DEVELOPMENT REVIEW BOARD REPORT

MEETING DATE: March 24, 2005

CASE NUMBER/ PROJECT NAME	80-DR-2003#2 Northsight Pads 3 & 4		
LOCATION	14826 & 14884 N Pima Road		
REQUEST	Request site plan and elevations approval for Northsight pad 3 (retail building) and pad 4 (Islands Restaurant).		
OWNER	Raintree Pads 3 & 4, LLC 913-262-6685	ENGINEER	JMA Engineering 602-248-0286
ARCHITECT/ DESIGNER	ADW Architects, PA 704-379-1919	APPLICANT/ COORDINATOR	Robert Lauer ADW Architects, PA 704-379-1919
BACKGROUND	<p>Zoning.</p> <p>The subject property is zoned Central Business District (C-2), which allows a variety of commercial uses including general retail and restaurants.</p> <p>The C-2 zoning district requires a conditional use permit for a bar. Because the Islands is a restaurant with a bar component, staff requested specific information about the Islands operations and floor plan to ensure that the use is not considered a bar as defined in the City's zoning code. Based on the information provided, staff has determined that the proposed use does not meet the definition of a bar.</p> <p>Context.</p> <p>Surrounding properties are zoned C-2, and include a bank to the south, and retail to the north a

SHEET NUMBER
A200

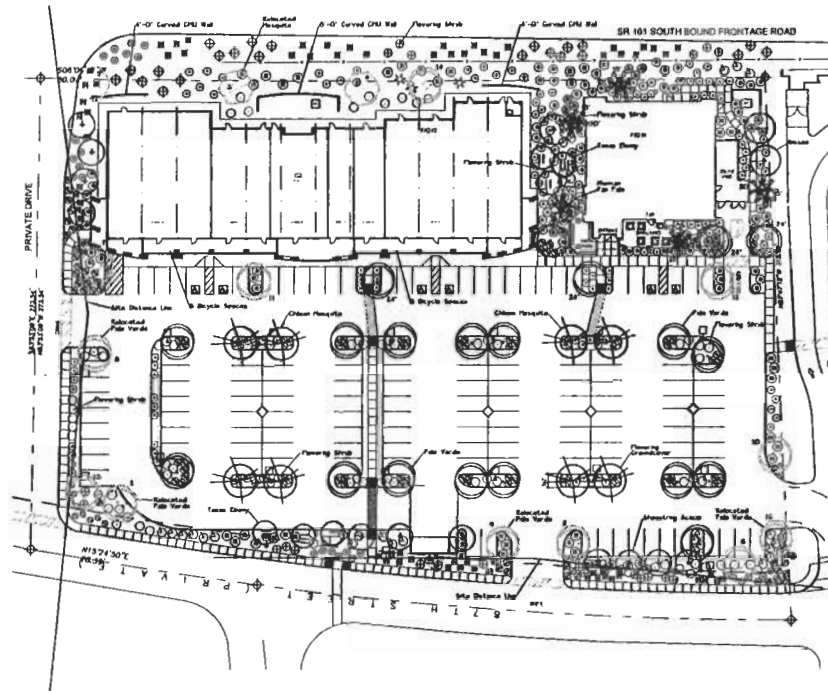
There are two key issues that relate to the awnings used in the Islands' Restaurant architecture. First, the applicant proposes fabric awnings with trim striping. In the past, staff has encouraged applicants to use a more durable, quality material such as metal or wood, although solid-colored fabric awnings

have also been allowed, especially on restaurants. In this case, the awning fabric is a bright blue color with some trim striping in green and yellow. While these awnings are not a solid color, the trim striping appears minimal, and staff has not included a stipulation to remove the green and yellow rim.

Second, the Islands Restaurant architecture includes gooseneck lighting of the awnings. In the past, the DRB has not supported lighting that serves only to illuminate building features for a billboard, or signage effect. The Islands' Restaurant has agreed to the included stipulation to delete the illumination of the awnings.

2. Awnings shall be non-illuminated.
3. The face of the service entrance section(s) internal or completely screened by a wall matching the architectural materials, colors, and finishes of the building to which it is attached.

19. The gooseneck lamps used to down-light the awnings shall not be permitted.
20. All exterior luminaries shall meet all IESNA requirements for full cutoff, and shall be aimed downward and away from property line except for parking lot canopy and landscape lighting.
21. Landscape lighting shall be low-voltage and not capable of supporting a lamp exceeding 50 watts, have extensor visor shields and not be located or directed to illuminate the building.
22. The individual luminary shall not exceed 250 watts.
23. The maximum height from finished graded to the bottom of the any exterior luminary shall not exceed 20 feet.
24. All exterior light poles, pole fixtures, and yokes, shall be a flat black or dark bronze.
25. Incorporate into the project's design, the following:
Parking Lot and Site Lighting:
